City of Carlisle, Iowa
Planning and Zoning Commission
Regular Meeting
October 19, 2020
7:00 P.M.
Carlisle City Hall

RE: **Summertime Potato Company – Preliminary Plat & Site Plan**

FOX Ref No: 8666-20B.240

Thank you for submitting your project for review. The City is committed to assisting you with the completion of this project. FOX Engineering and the City Staff have completed the second review for the Summertime Potato Preliminary Plat & Site Plan dated October 12, 2020 and have the following comments:

SUMMERTIME FLAT I
 1105 SE 12ND AVENUE, CARLISLE, IA 50047
DIMENSION PLAN - NORTHWEST

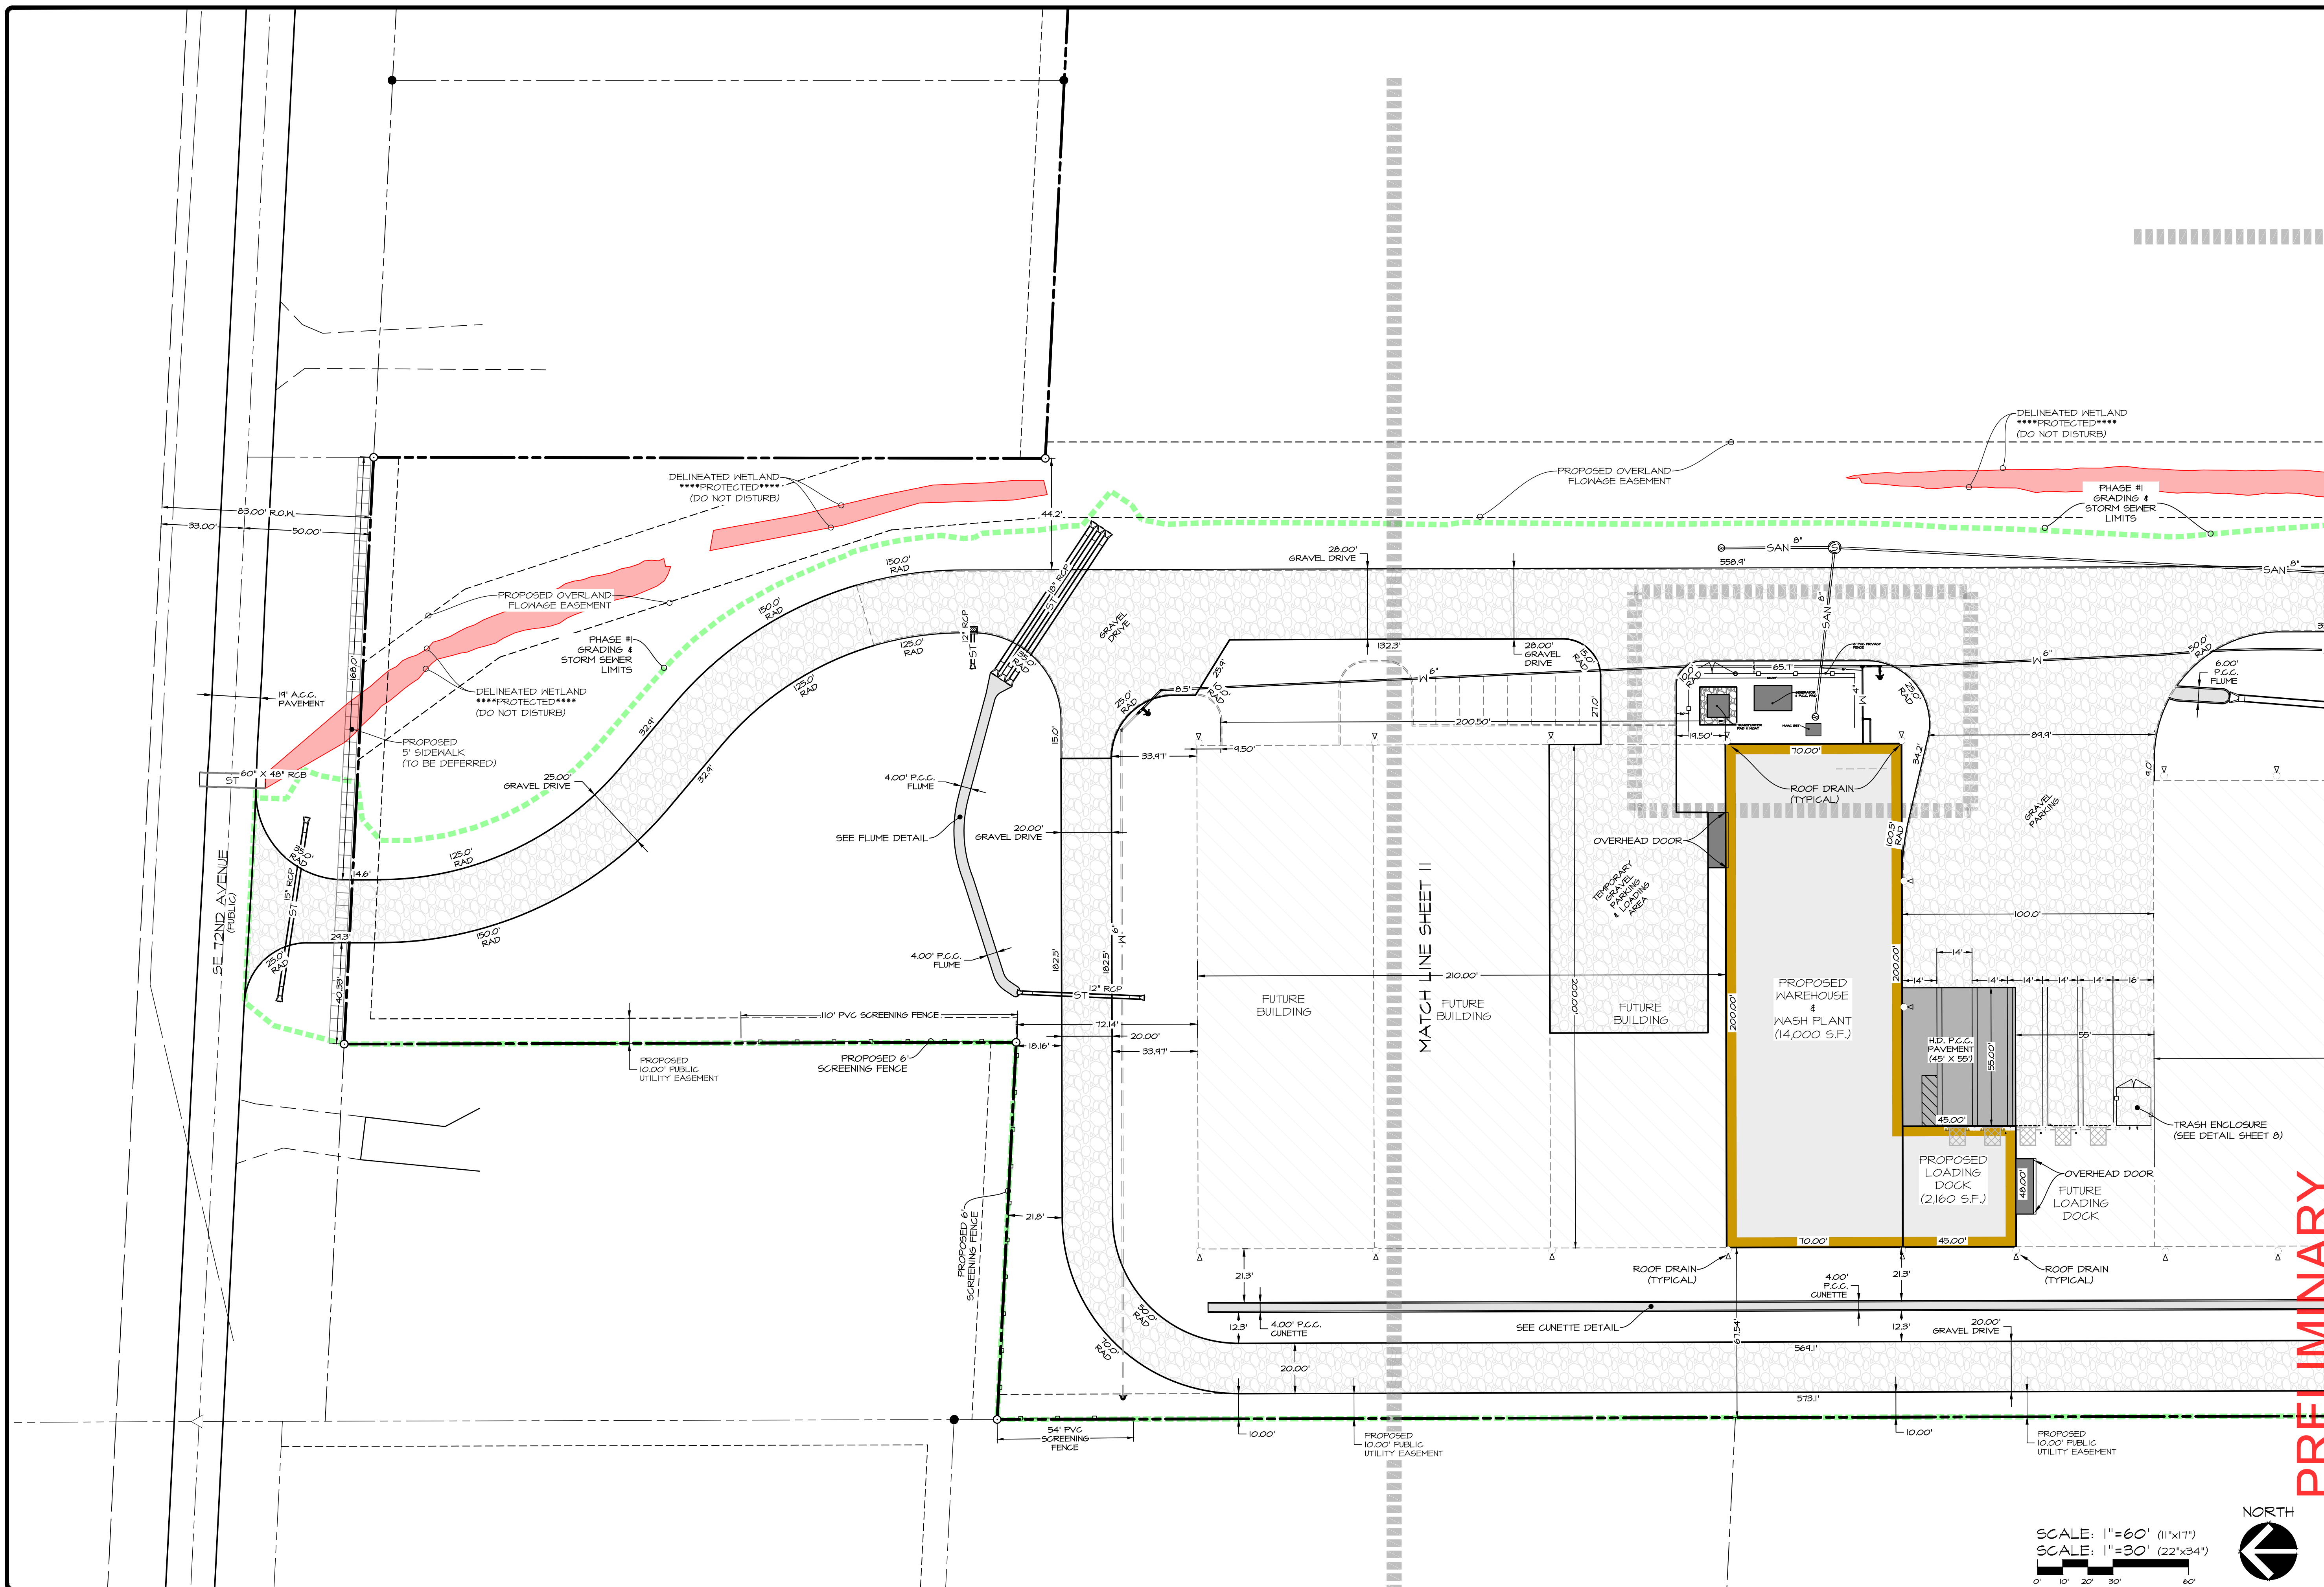
19. Please list the square footages of the proposed structures.
20. The trash enclosure shown on Sheet 8 is made of Cedar or PVC Panels. Carlisle Code states that the screened garbage collection areas shall be of similar building material as the primary building (primary building elevations have yet to be provided). Further **discussion is necessary** regarding what is proposed and what the City will allow for trash enclosure for this site.
21. Please show the locations of man doors on these sheets.

SUMMERTIME FLAT I
1105 SE 12ND AVENUE, CARLISLE, IA 50047
UTILITY PLAN - SOUTHEAST

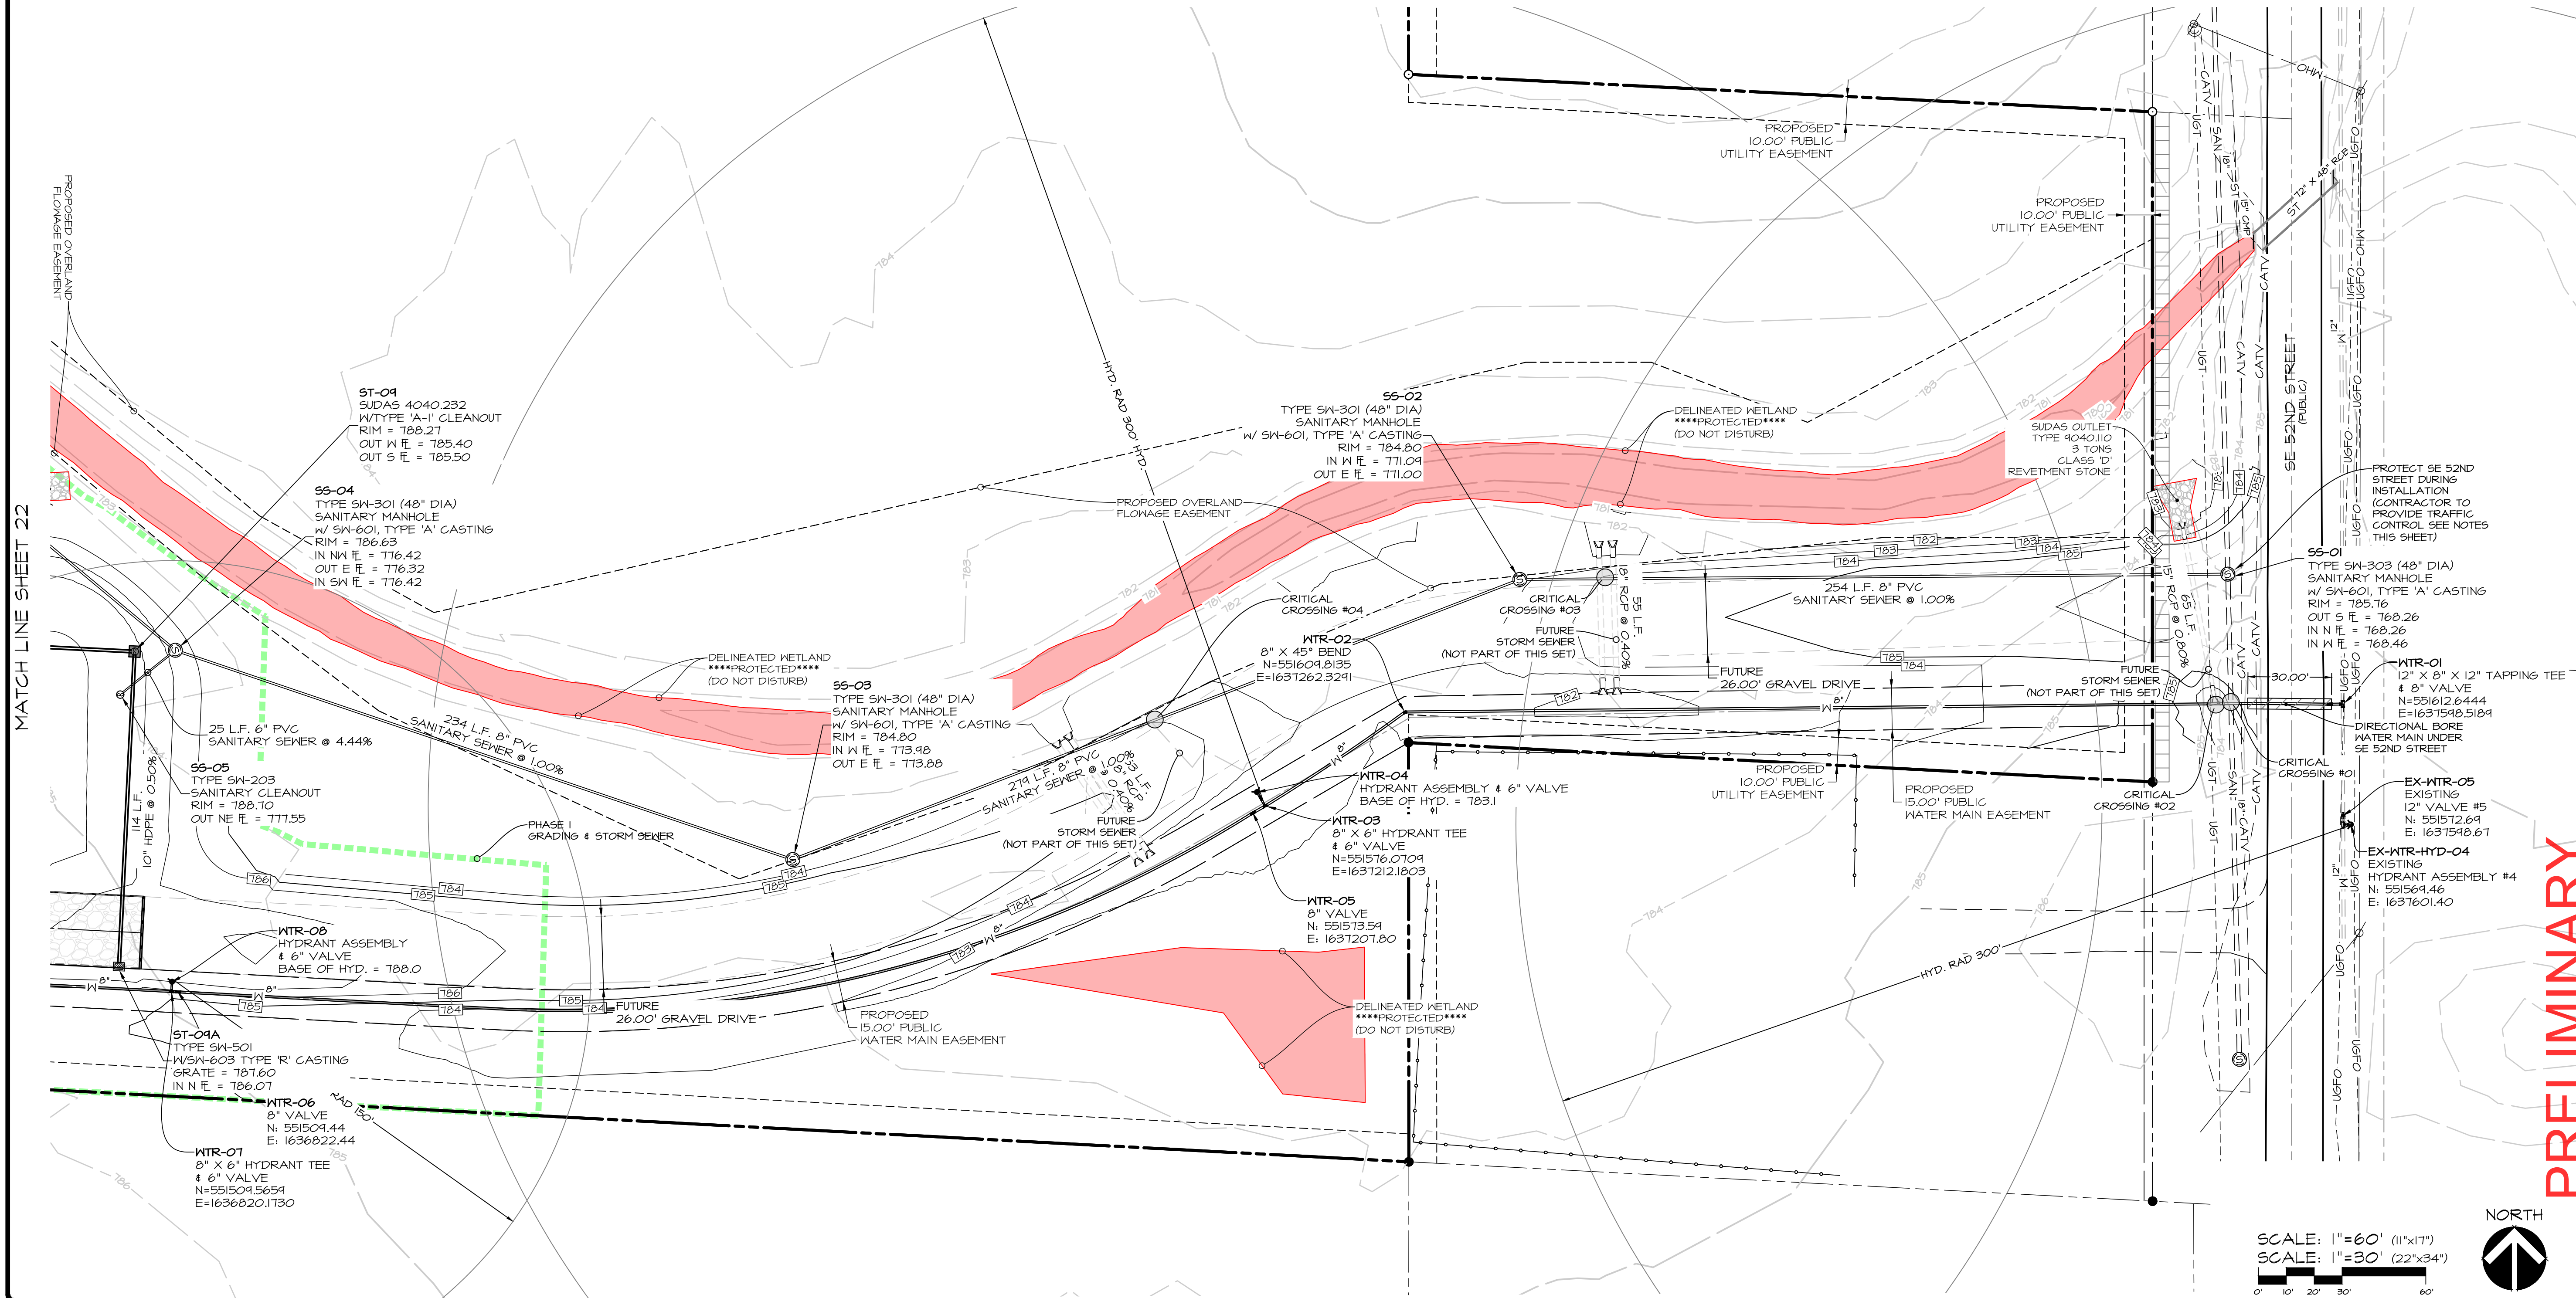
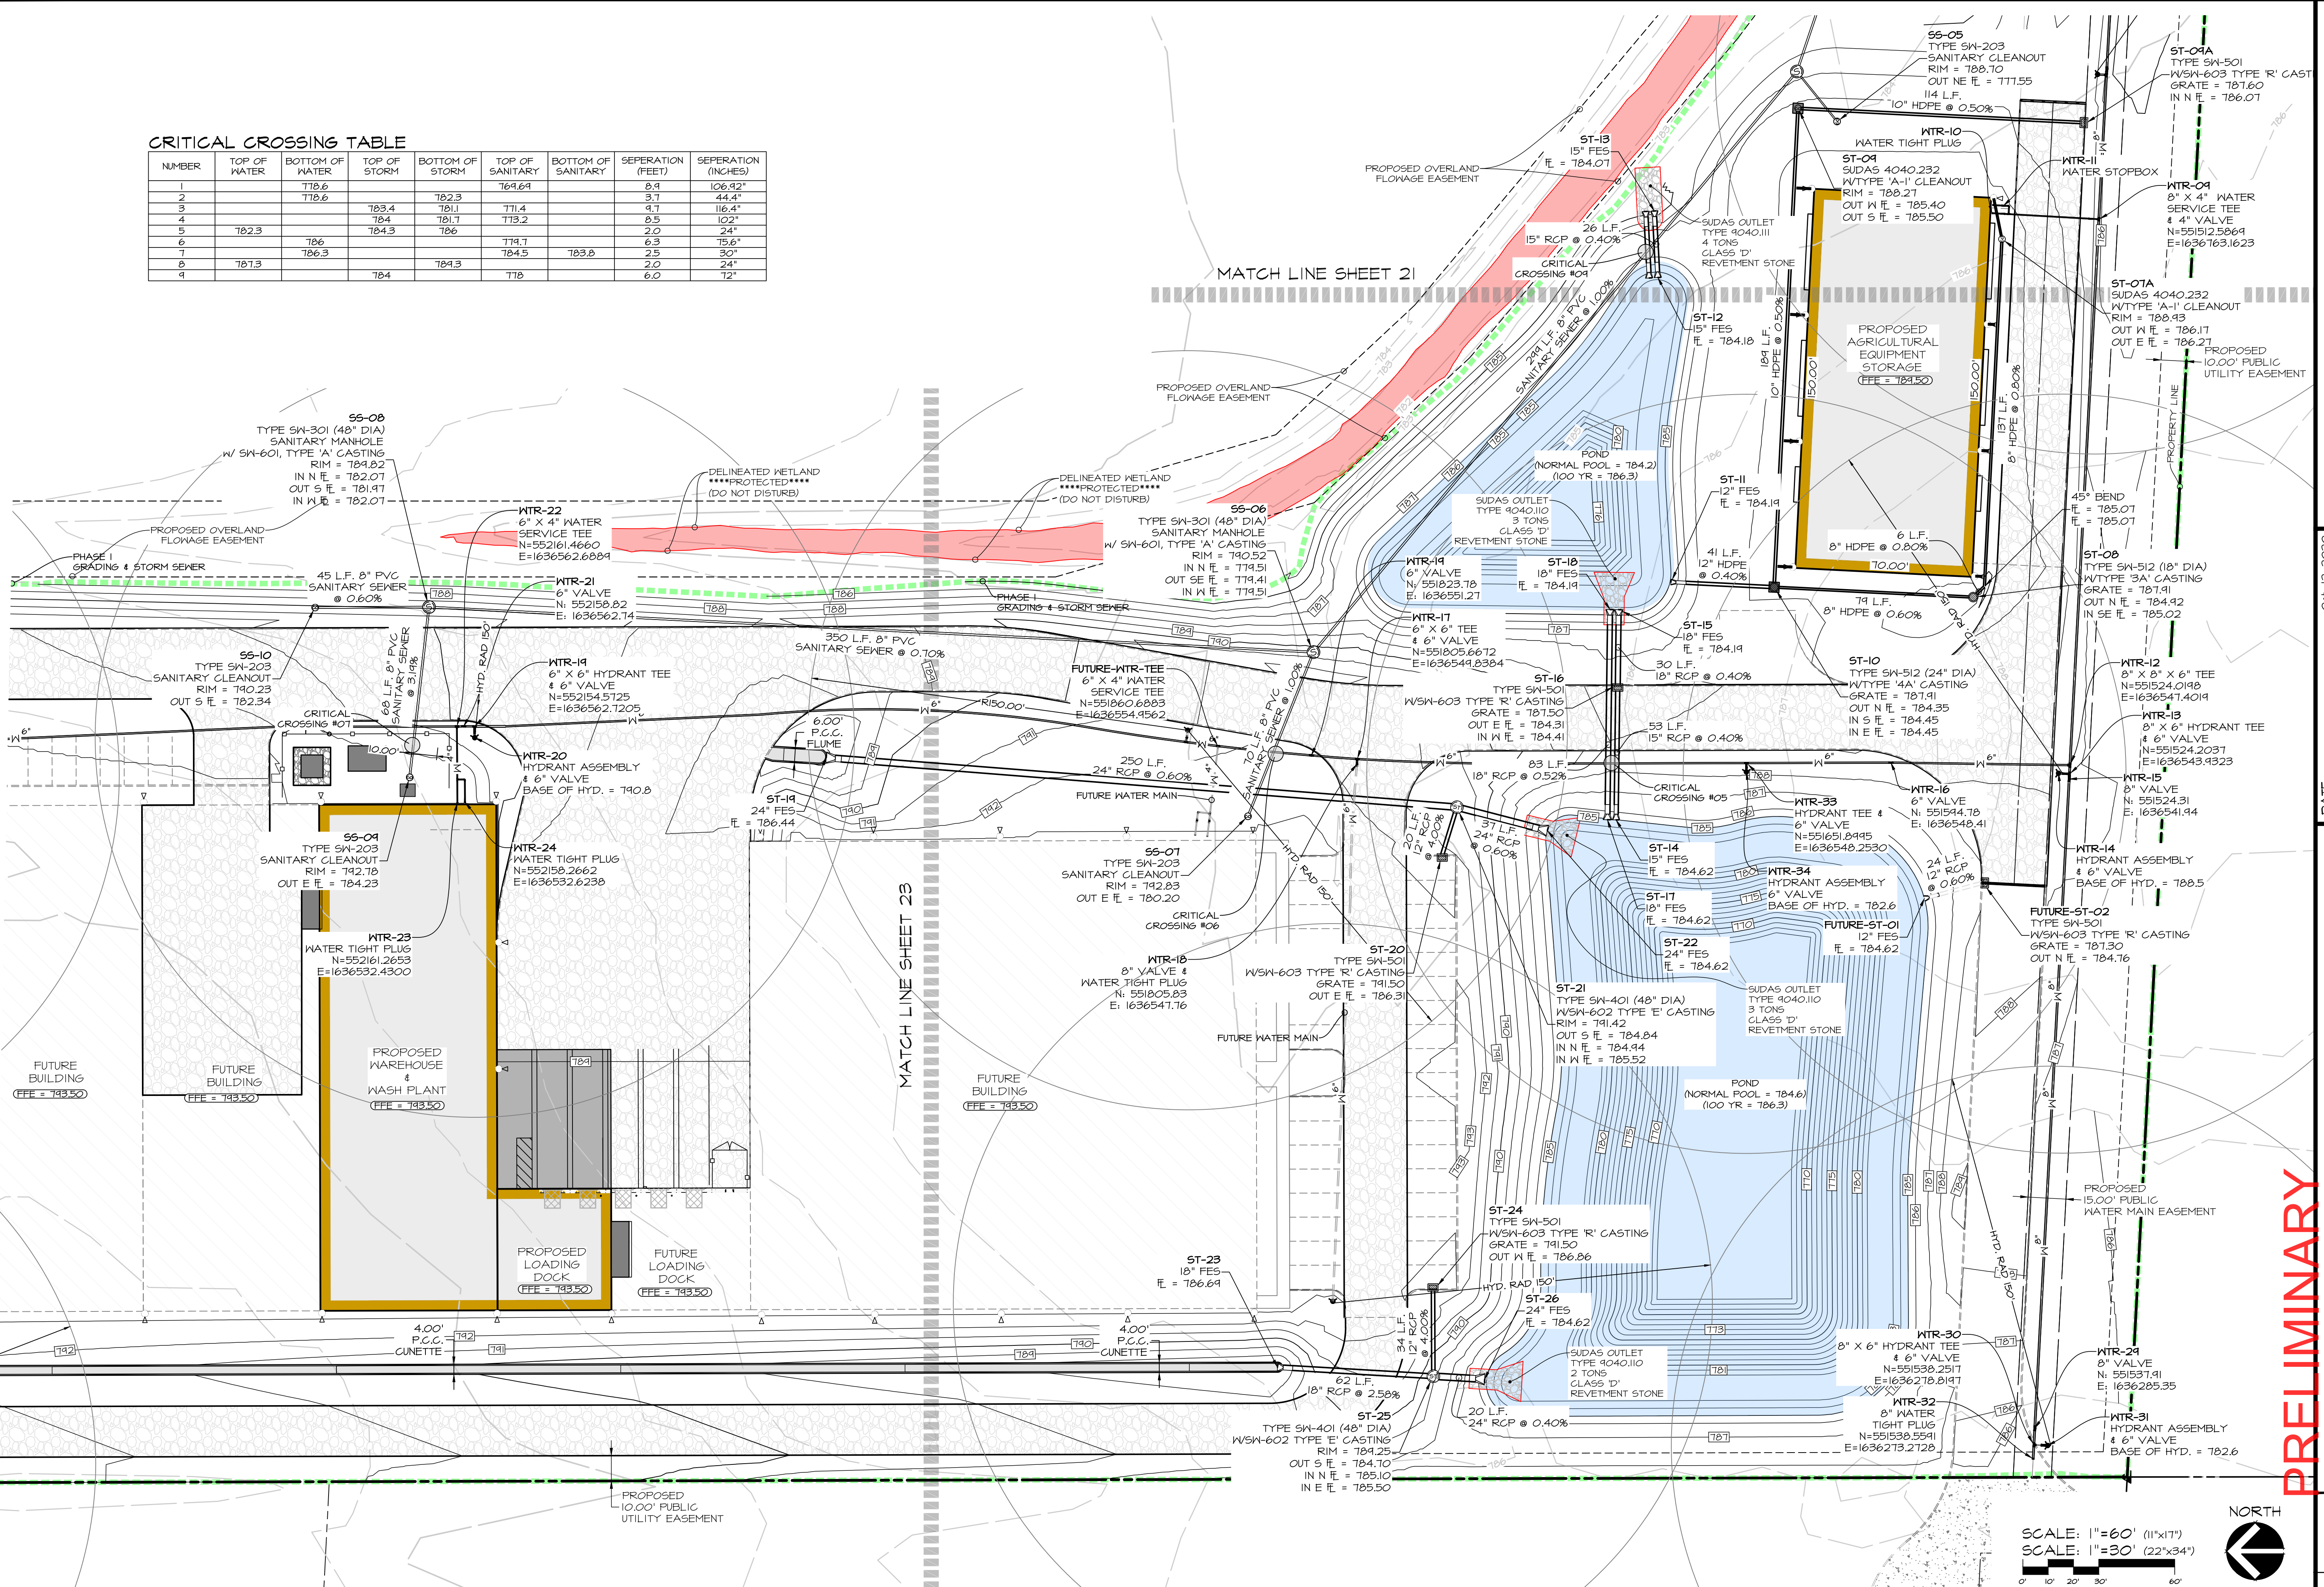
22. We understand that the site may require a sand/oil separator due to the amounts of soil that may enter the sanitary sewer waste system. This should be determined prior to construction after discussion with the wash plant manufacturer.
23. Please show the location of the post indicator valve on the utility sheets.
24. Please provide 225' radii for the hydrants along the east access. It appears that the hydrant near the NW corner of the Goodhue property could be moved westerly to provide more spacing.
25. Please dimension the erosion control placement throughout the site plan.
